FILE P.I. # 0005320 **OFFICE** Design Policy & Support
NHS00-0005-00(320)
Dooly County
GDOT District 3 - Thomaston **DATE** January 24, 2013
I-75@SR 215 Interchange Improvements

SUBJECT APPROVED REVISED CONCEPT REPORT

Project NHS00-0005-00(320) (I-75 @ SR 215 Interchange):

**DEPARTMENT OF TRANSPORTATION
STATE OF GEORGIA
REVISED PROJECT CONCEPT REPORT**

ATTACHMENT 4
TRAFFIC DIAGRAMS

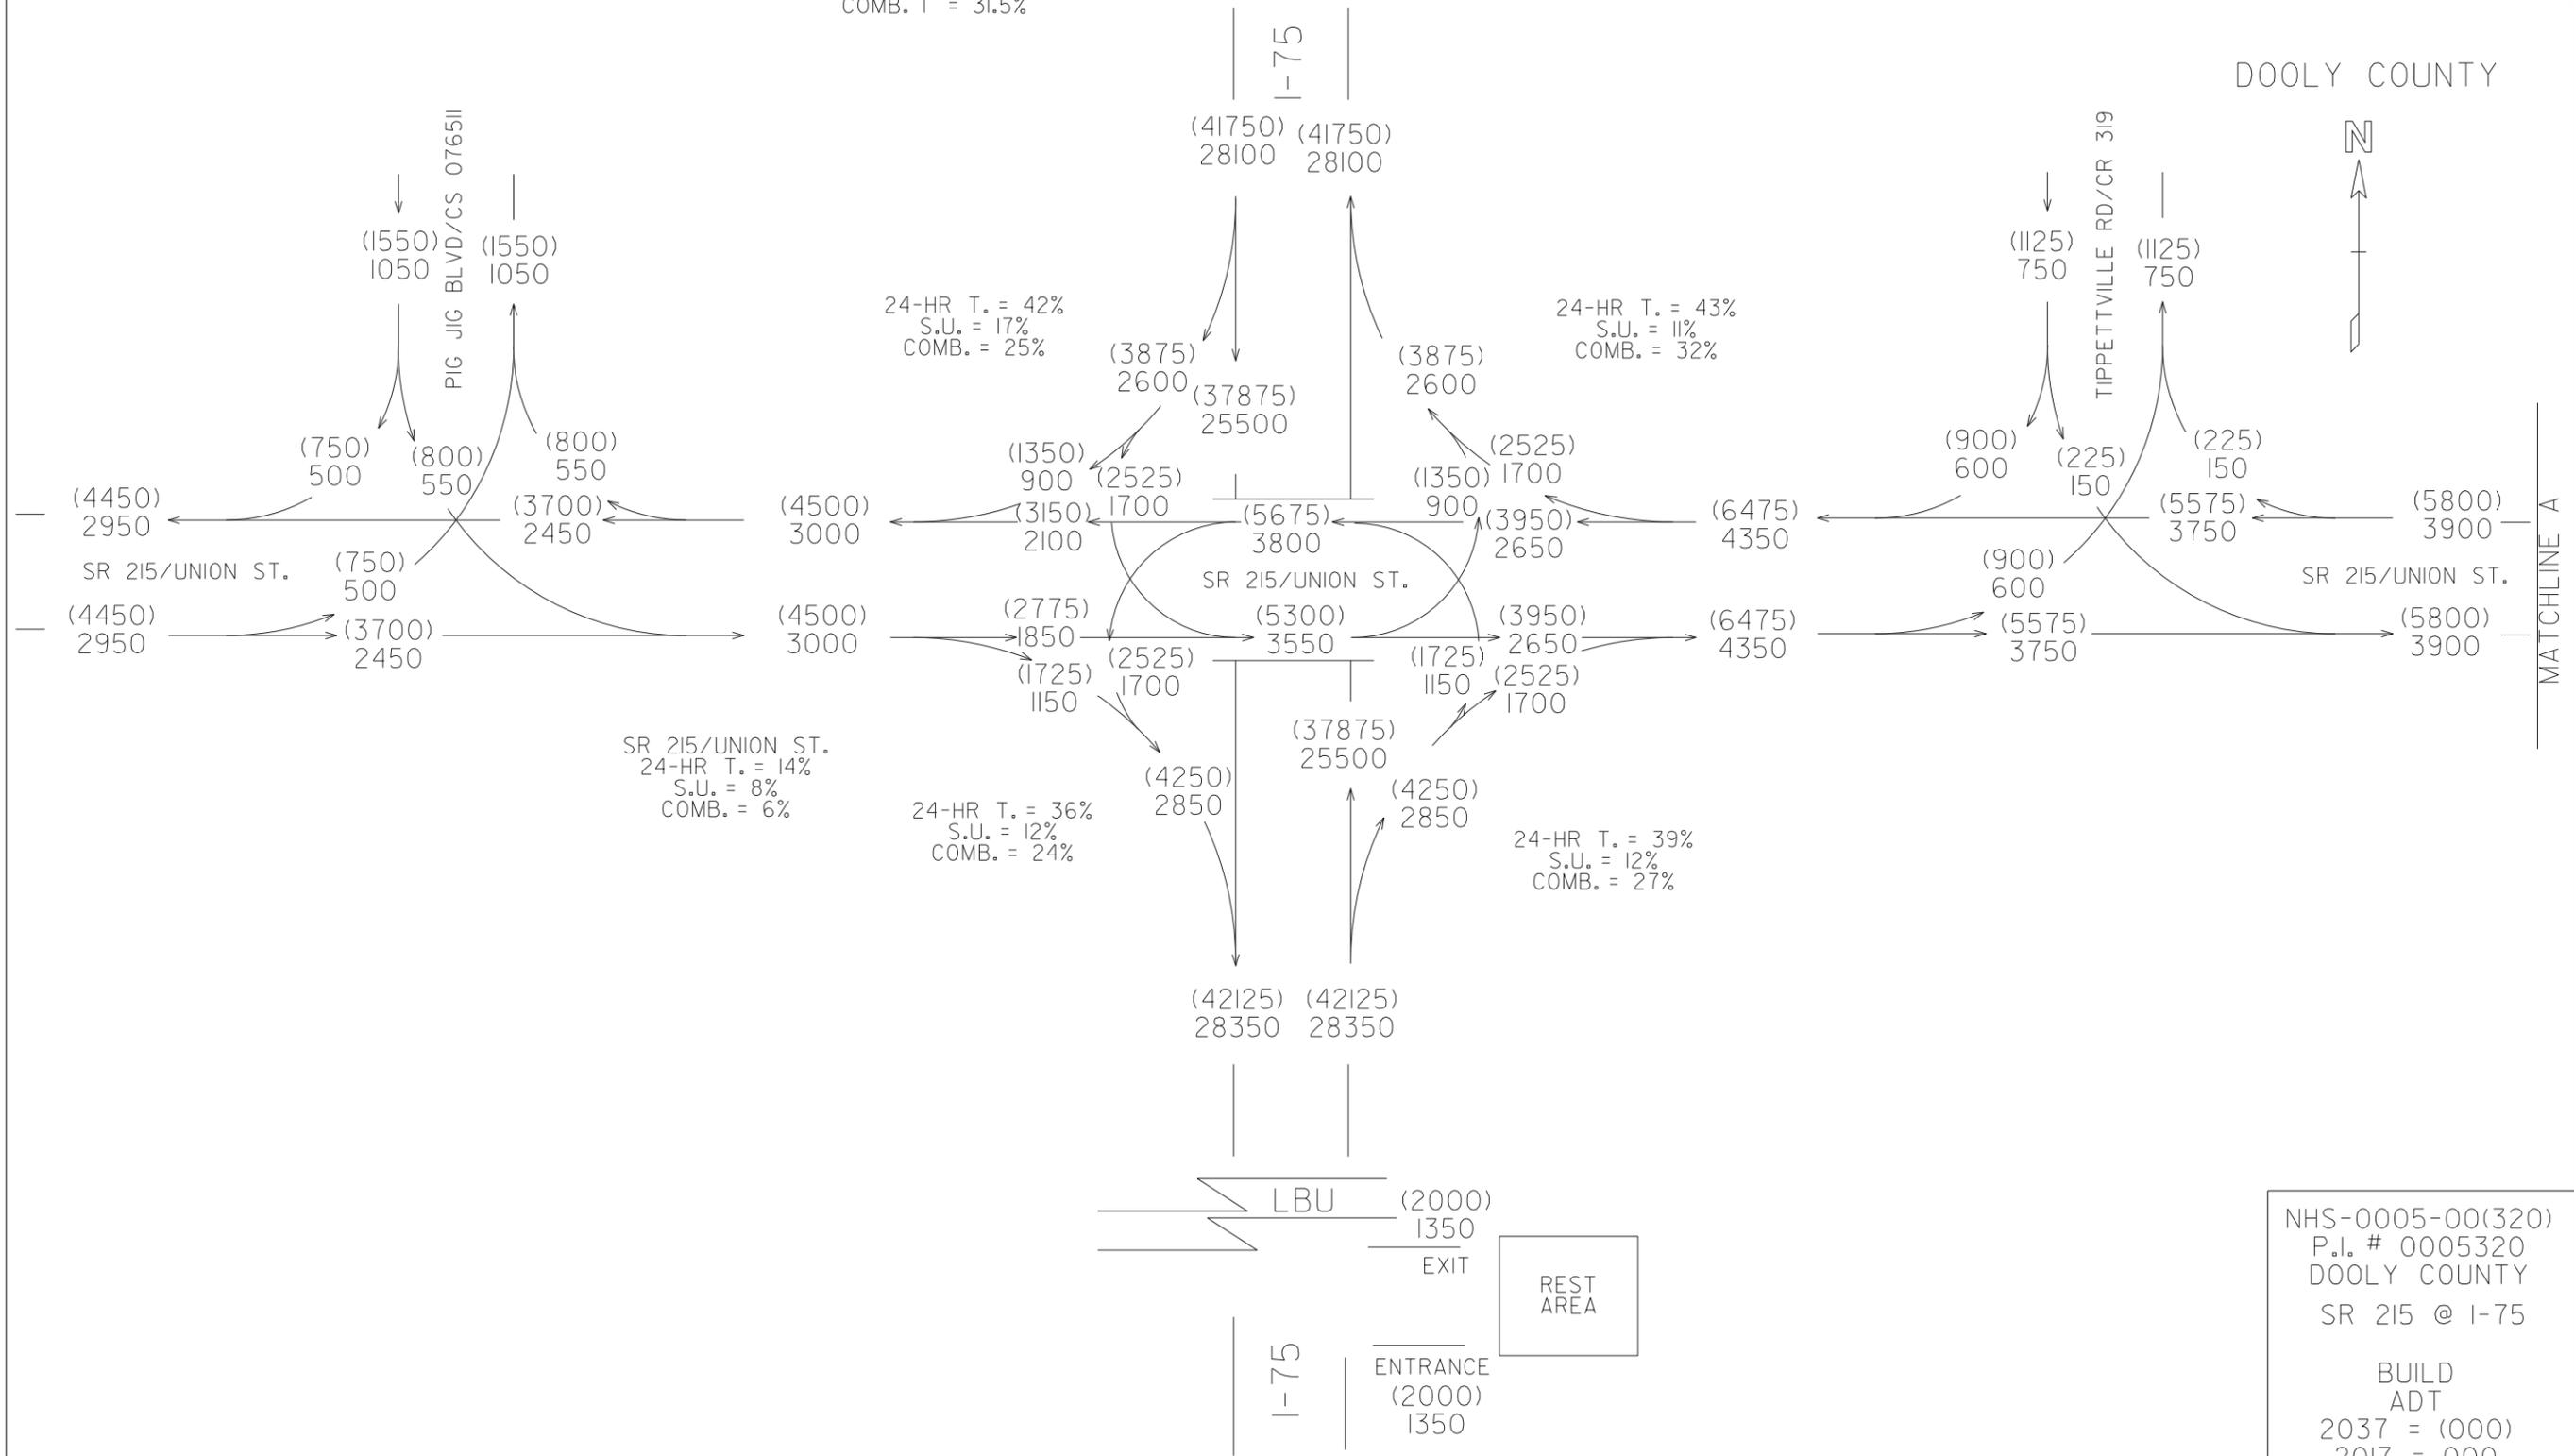
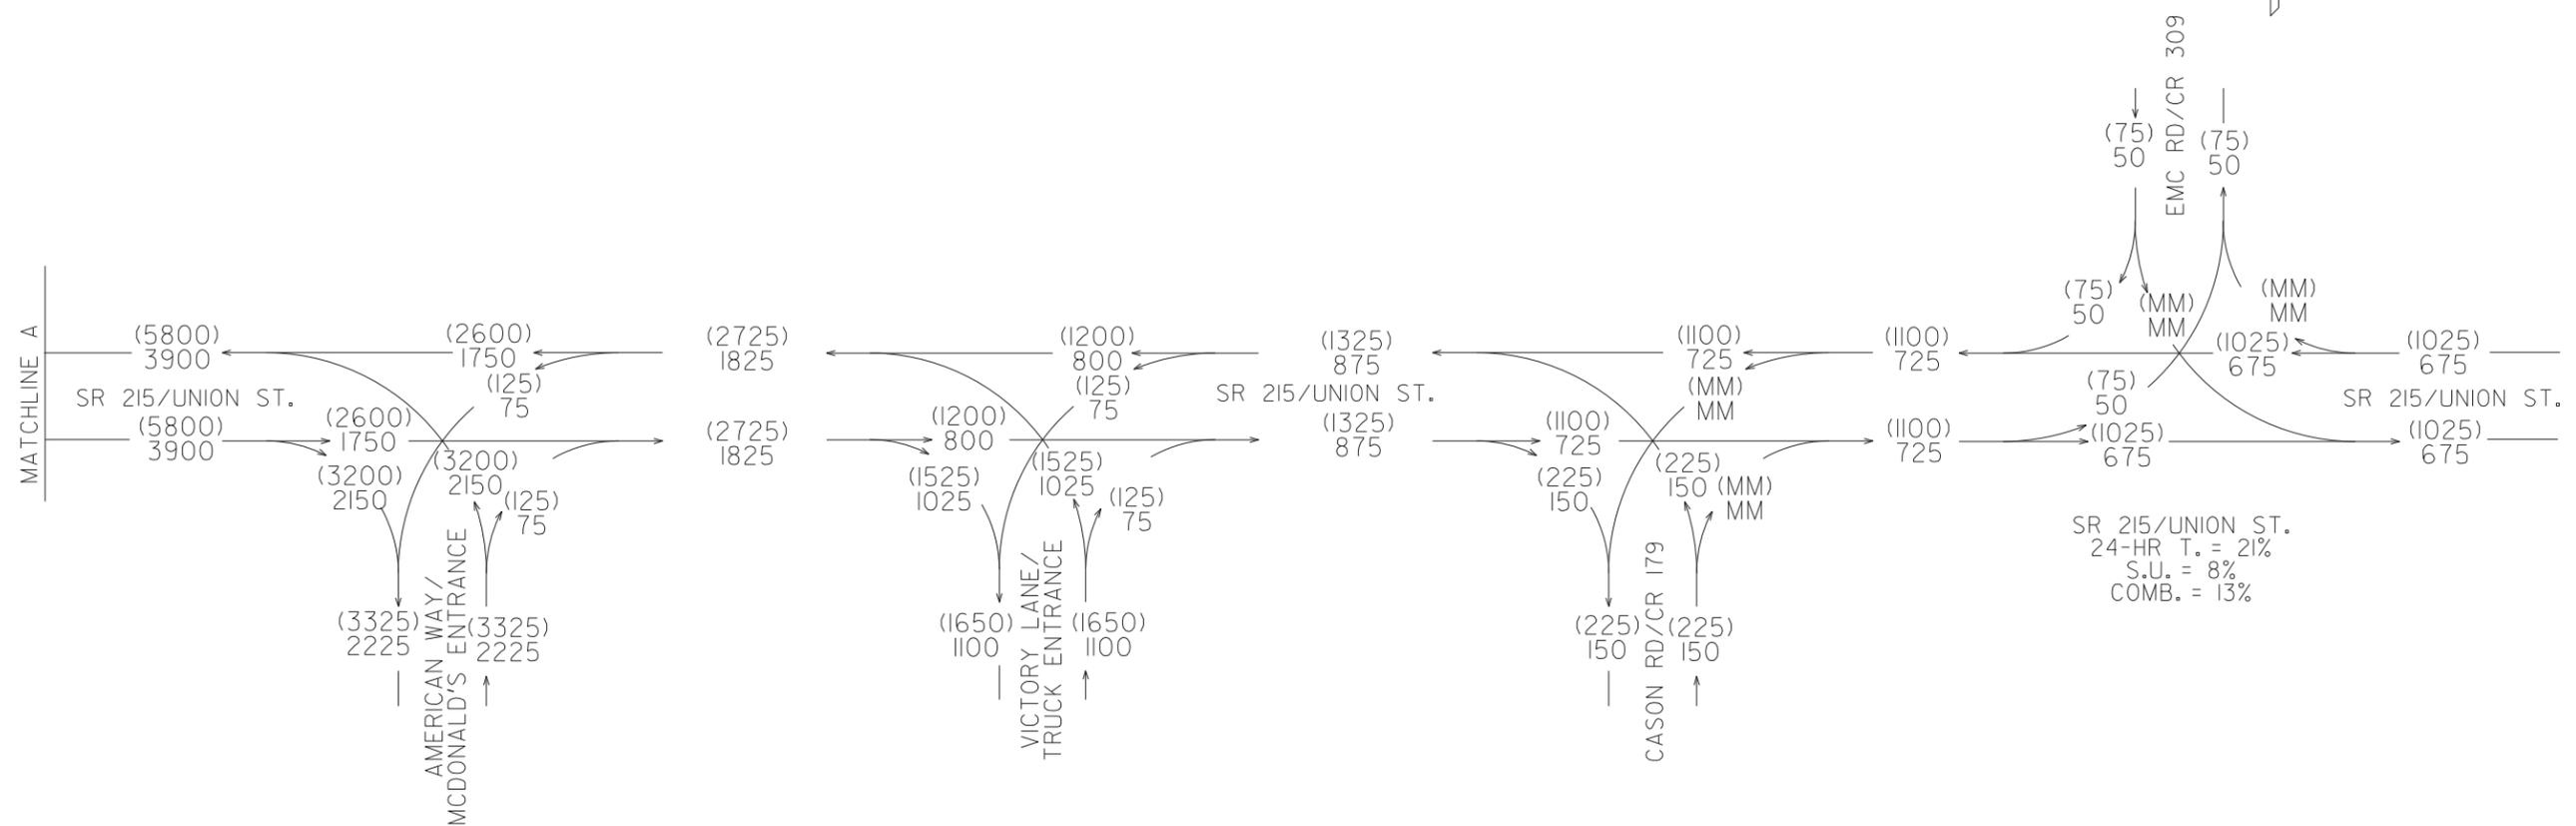
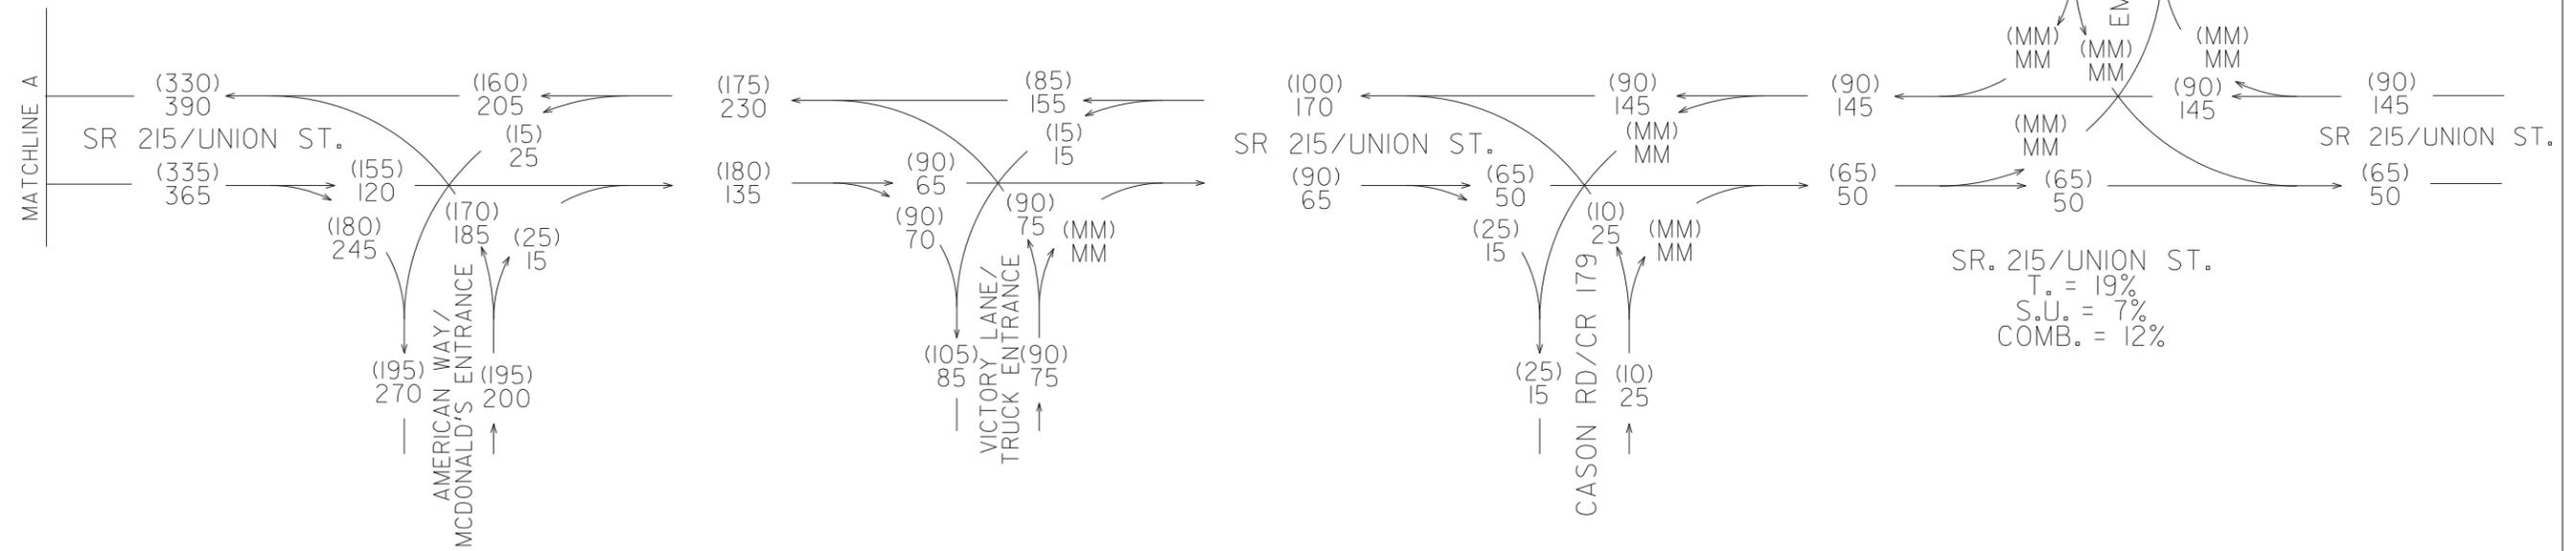
- The Traffic Diagrams provided for the proposed project Build Condition do not reflect the description of the Build Condition of the proposed project. Please review the project information and ensure that all related project information is consistent with the proposed project, as analyzed by GDOT.
- Please ensure that all data presented within the report is accurate and consistent.
